TO: Matthew K. Takita, Director of Building and Planning
FROM: Harold W. Gans, Township Engineer
SUBJECT: Zoning Review for 2722 Street Rd, TP #02-037-032
DATE: May 24, 2016

ZONING SITE PLAN

RETAIL STORE

2722 STREET ROAD

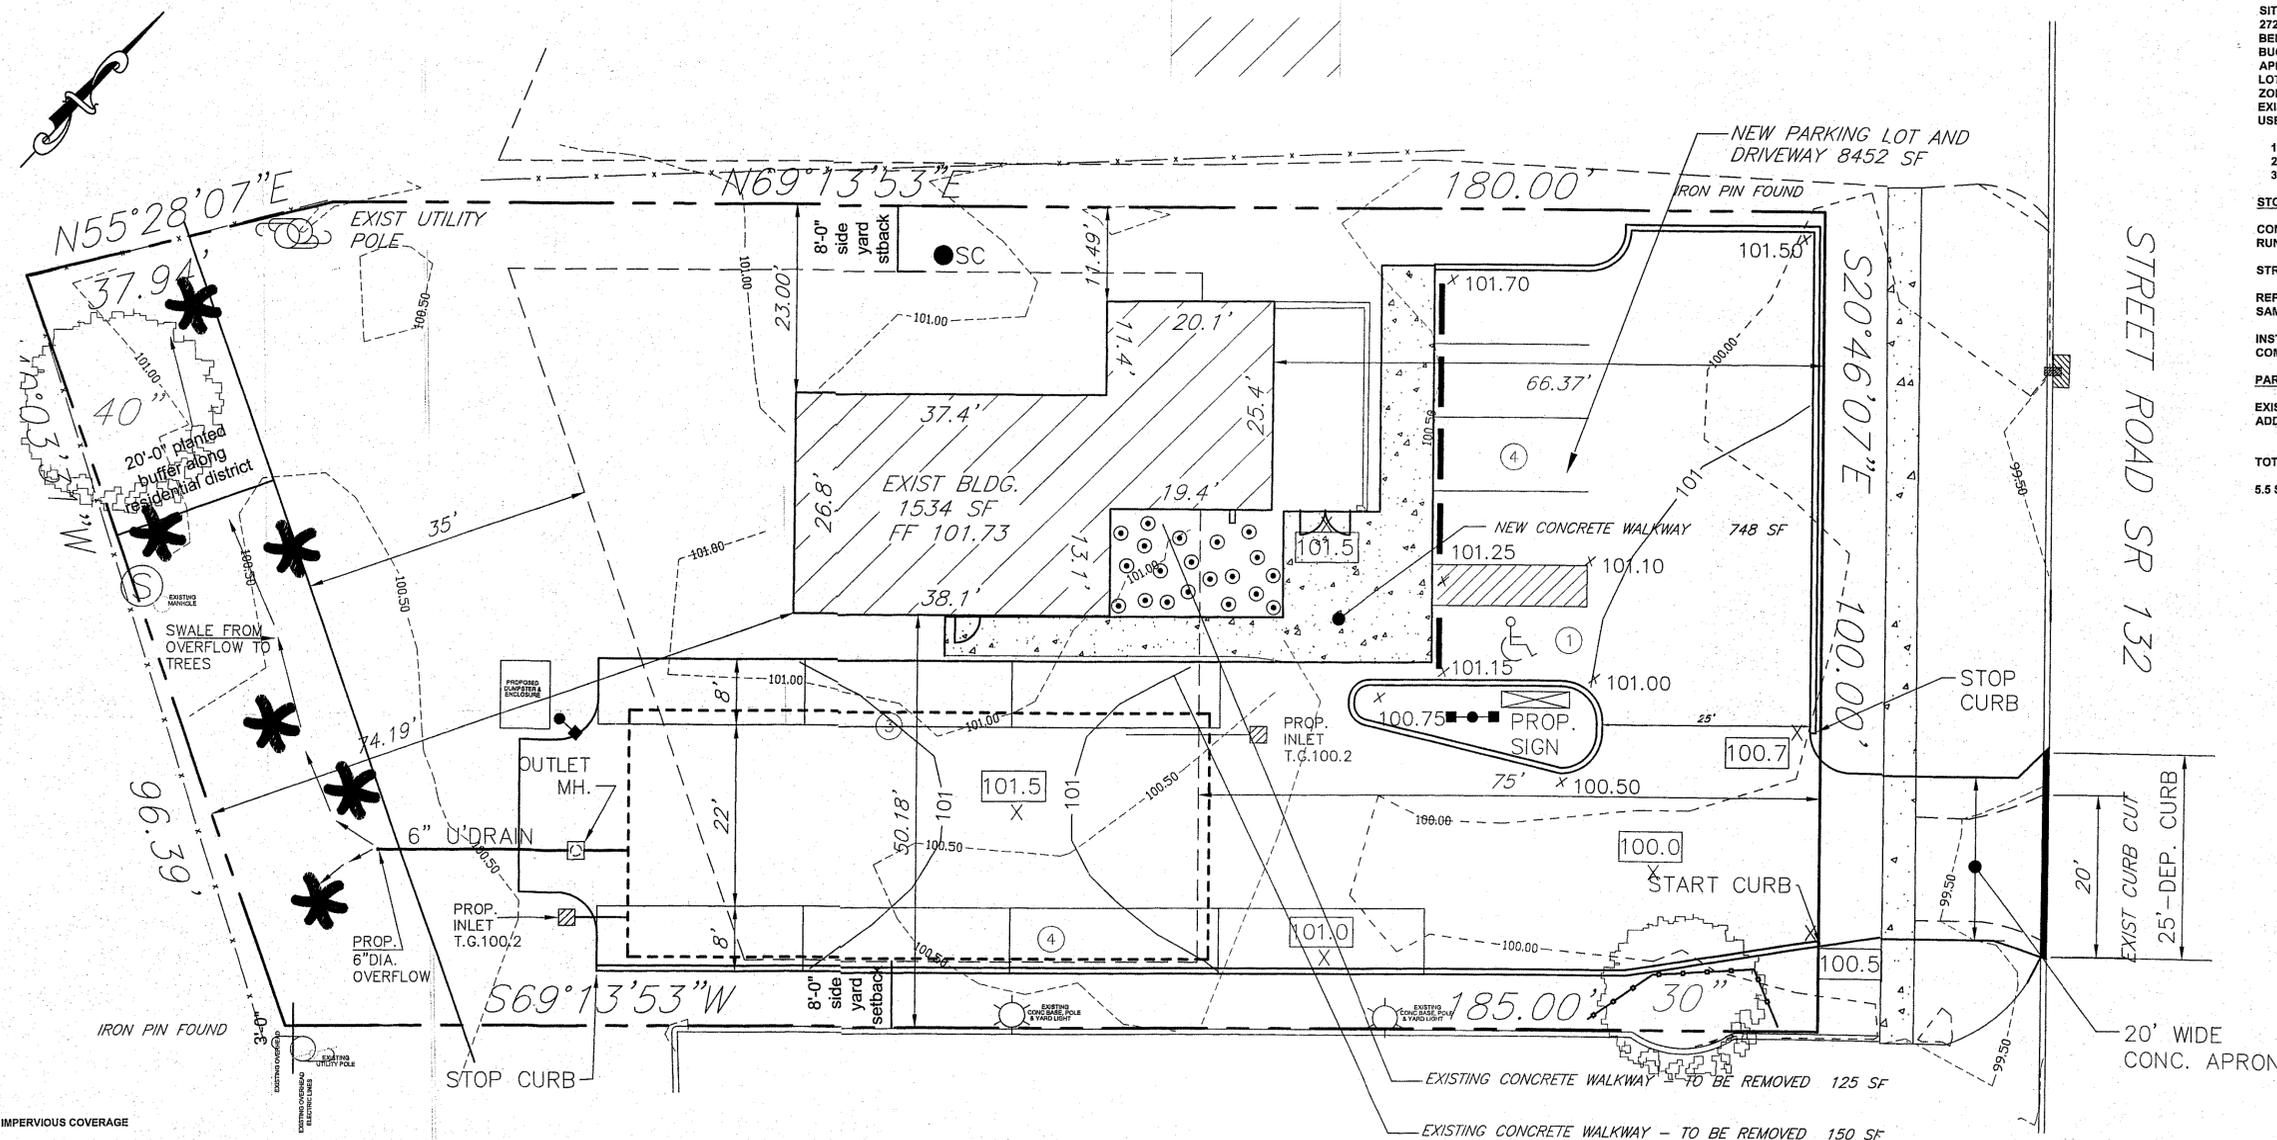
1. The required 25 ft setback for parking lots has not been provided.
[Section 232-586(d)(3)b.]
2. The required loading and unloading space has not been provided.
[Section 232-587(1)(2)]
3. The required 24 ft wide aisle width for two way traffic has not been provided at the entrance drive and in the south side parking lot. [Section 232-586 (b.)(1)]
4. The proposed sign size, height and text have not been provided.
[Section 232, Article XIV Signs]
5. Planting details of the 20 ft buffer yard must be provided.
[Section 232-592(1)(2)(a. through f)]

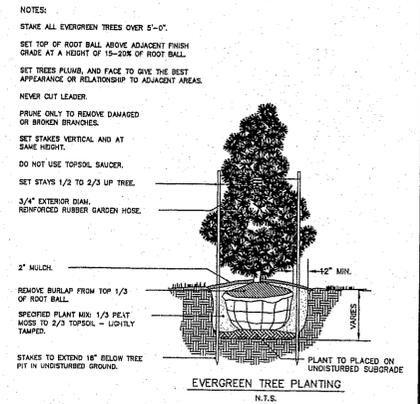
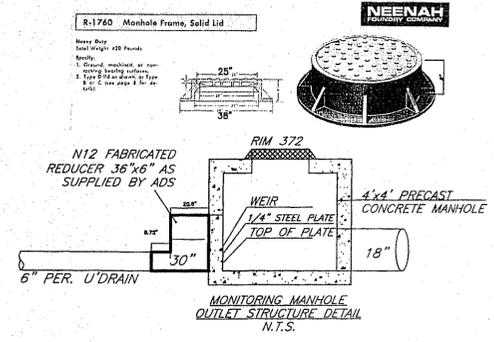
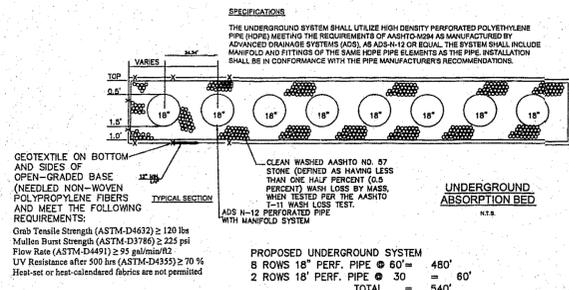
1. The plan notes indicate a proposed addition but it is not depicted on the plans.
2. The review is for **ZONING ONLY**. Should the necessary variances be granted the remainder of the plans will be reviewed for land alteration compliance with the Subdivision and Land Development Ordinance.
